Permit Application Review Report
Date: 3/19/2025

Project Name: Street Reconstruction Project 25-1

Project PAN: P-25-006

Project Purpose: reclamation and reconstruction of various City streets

Figure 2: Site Plan

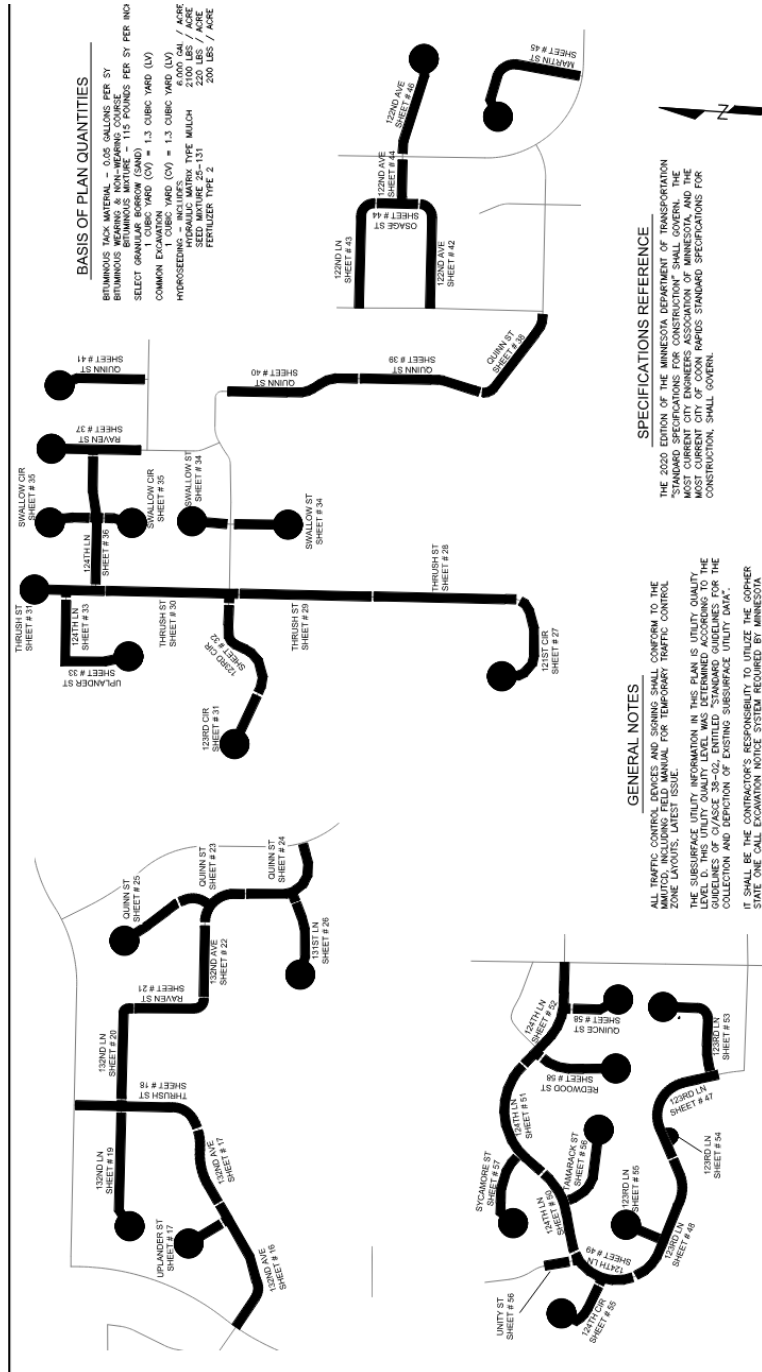
2. A 6-foot diameter, 6-foot sump with a SAFL Baffle was added to the construction plans for CB 26. For documentation purposes, please update the permit narrative to reflect this and include the TSS removal efficiency of the structure in the SHSAM Results table.
